STAFF REPORT
COMMUNITY DEVELOPMENT DEPARTMENT

SUBJECT: H-2022-0073 – Meridian Oz – MDA, CUP

LOCATION: 1475 E. Franklin Rd., in the NE 1/4 of Section 18, T.3N., R.1E. (Parcel #S1118110051)

1 SITE PLAN
SCALE: 1" = 40'

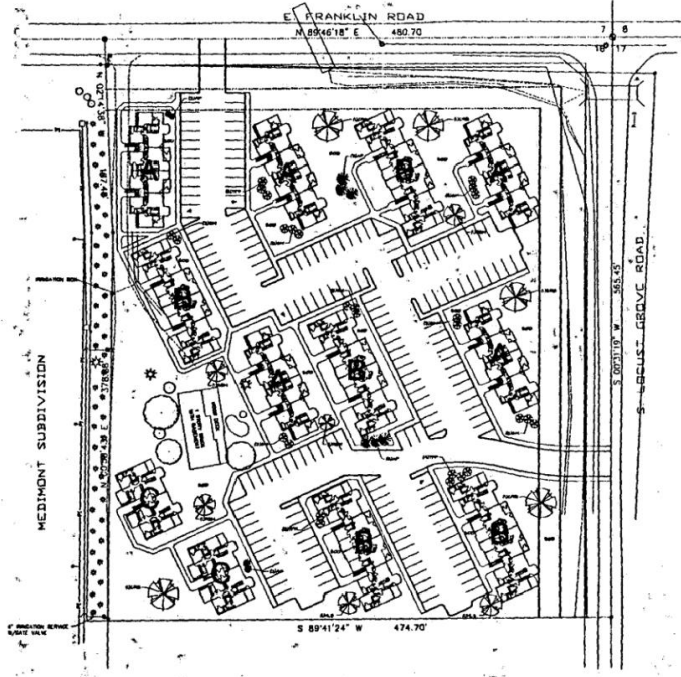
The existing conceptual development plan included in the DA is for a 96-unit apartment complex/multi-family development on 6.16 acres of land at a gross density of approximately 15 units/acre. The proposed plan is for a 60-unit apartment complex/multi-family development on 2.39 acres of land at a gross density of 25 units/acre. The development area has reduced in size due to ACHD purchasing the property at the Franklin/Locust Grove intersection for a drainage facility and right-of-way dedication for abutting roadway improvements.

Staff has reviewed the existing DA provisions in Section VIII.A and recommends the provisions pertaining to outside lighting, perimeter fencing and drainage be carried over to the new agreement. New provisions are recommended requiring future development to be generally consistent with the development plans proposed with this application and vehicular & pedestrian connectivity to be provided to the property to the south for future interconnectivity (see Section IX.A).

TYPICAL FLOOR PLAN (LEVEL 1-3)

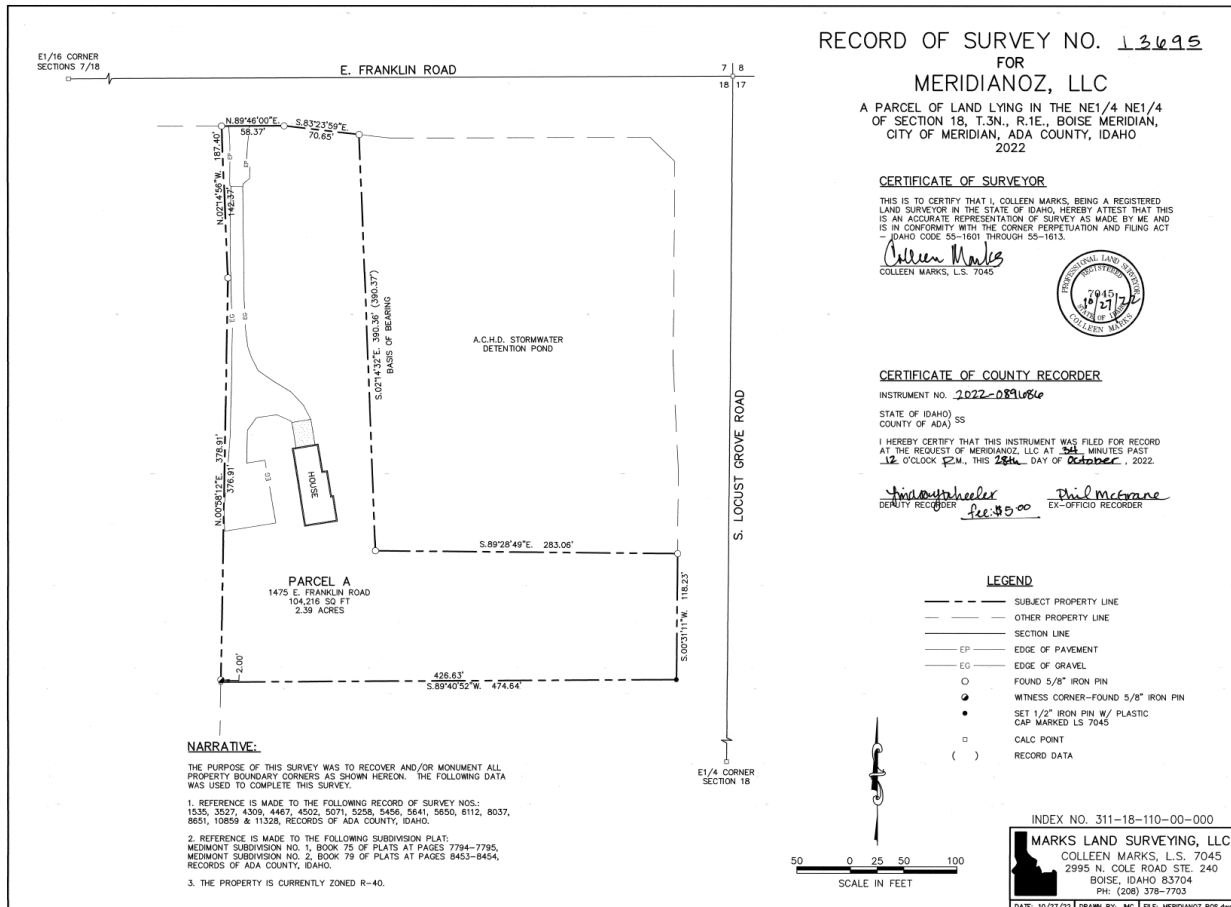
3. Floor plans should be submitted with the Certificate of Zoning Compliance application that demonstrate compliance with the private open space standard of 80 square feet for each unit, per UDC [11-4-3-27B.3](#).
